SUBJECT: Calvert Cliffs Nuclear Power Plant
Unit Nos. 1 & 2; Docket Nos. 50-317 & 50-318
License Amendment Request: Revise Technical Specifications Regarding
Control Room Habitability in Accordance with TSTF-448 Using the
Consolidated Line Item Improvement Process

- Attachments:
- (1) Technical Basis and No Significant Hazards Consideration
 - (2) Marked up Technical Specification Pages
 - (3) Marked up Technical Specification Bases Pages

MARKED UP TECHNICAL SPECIFICATION PAGES

SR 3.7.8.4 Perform required CRE unfiltered air intake testing in accordance with the Control Room Envelope Habitability Program

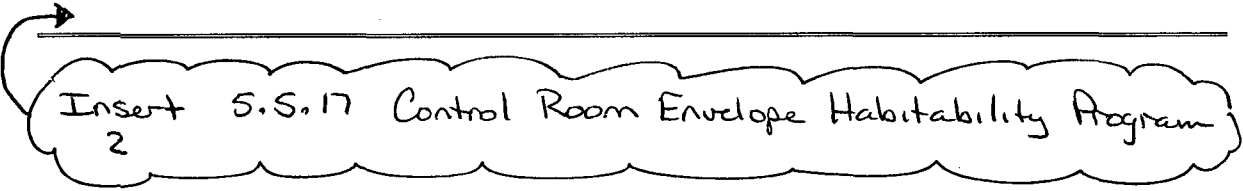
In accordance with the Control Room Envelope Habitability Program
